DESIGN REF 78-8063-5801-2	NEXT ASSY	NOTES	
REF SCALE 20X	DFTGTA BURTON	DATE 7-16-93	MODEL 89
TOLERANCES EXCEPT AS NOTED	CHKD	DATE	DIVISION ELECTRONIC PROD.
mm	MFG	DATE	DIVISION CODE 1500
.0 ±.000	APPVL	DATE	
.00 ±.000	THIS DOCUMENT CONTAINS INFORMATION WHICH IS PROPRIETARY TO 3M COMPANY. NO REPRODUCTION OR PUBLICATION OF THIS DOCUMENT, IN WHOLE OR IN PART, SHALL BE MADE WITHOUT AUTHORIZATION FROM 3M.		
.000 ±.000	INTERPRET PER ANSI Y14.5M-1982		
ANGLES ± 2°	THIRD ANGLE PROJECTION		
MATERIAL	FSCM NO.	SIZE	DRAWING NO.
FINISH	D	78-8063-5802-0	G
	DO NOT SCALE DRAWING		DET LISTS <input type="checkbox"/> YES <input type="checkbox"/> NO
			SHT 1 OF 1

DRAWING NO. 78-8063-5802-0

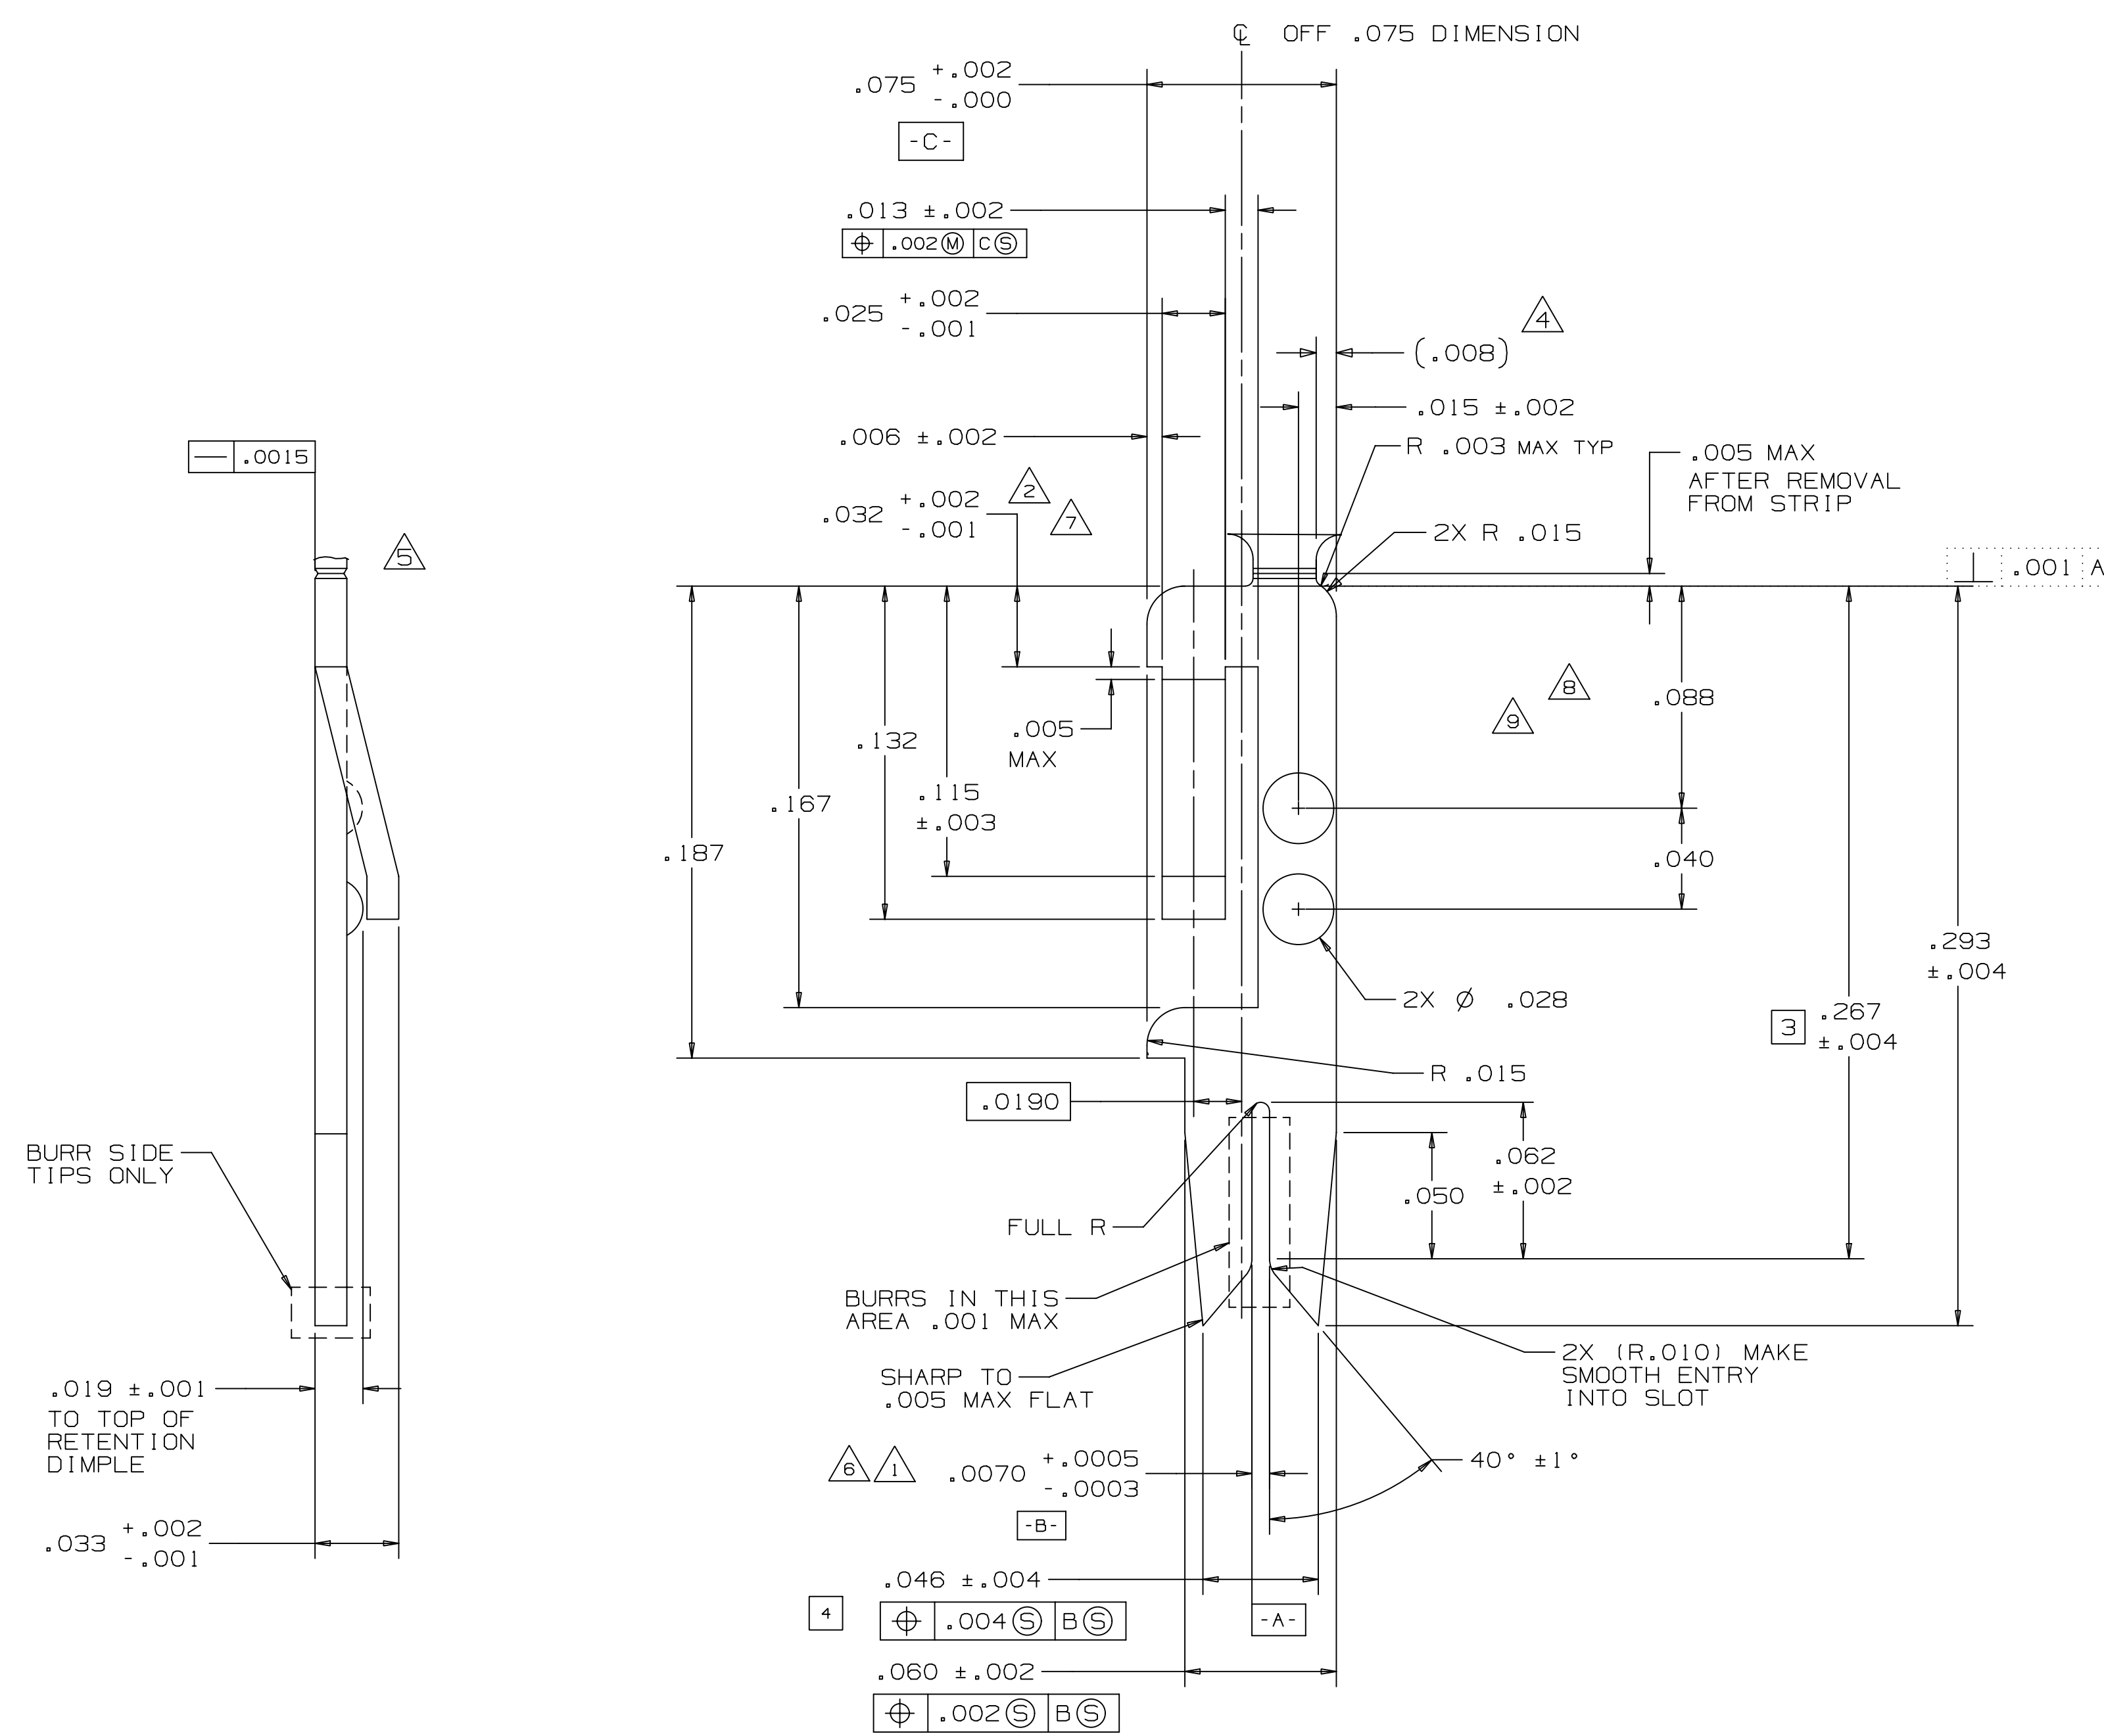
REVISION RECORD					
REV	ECO	DESCRIPTION	DRFT	CHKD	
A	027-93	REVISED & REDRAWN REVISED ON 21-JUL-93 AT 10:00 FOR PREVIOUS REVISIONS ON THIS DRAWING SEE 78-8063-5801-2	TAB	RAH	
E	003-94	01-11-94 1 WAS .0076±.0005 2 WAS .032±.000	TAB	PSD	
F	036-94 021-96	09-09-96 3 ADDED 26 TO TITLE DELETED BEND PICTORIAL ADDED STRAIGHTNESS DIMENSION DOCUMENT NOTE: REVISIONS B,C & D DO NOT EXIST	TAB	RAH	
G	078-97	10-14-97 4 RELOCATED CARRIER STRIP ATTACHMENT LOCATION TO .008 FROM EDGE 5 ADDED SCORING CHAMFERS 6 PER ECO 003-94 THIS TOLERANCE SHOULD BE +.0005/- .0003 7 PER ECO 003-94 THIS TOLERANCE SHOULD BE +.002/- .001 8 REMOVED .018 9 REMOVED .073 10 REMOVED NOTE 2	TAB	BG
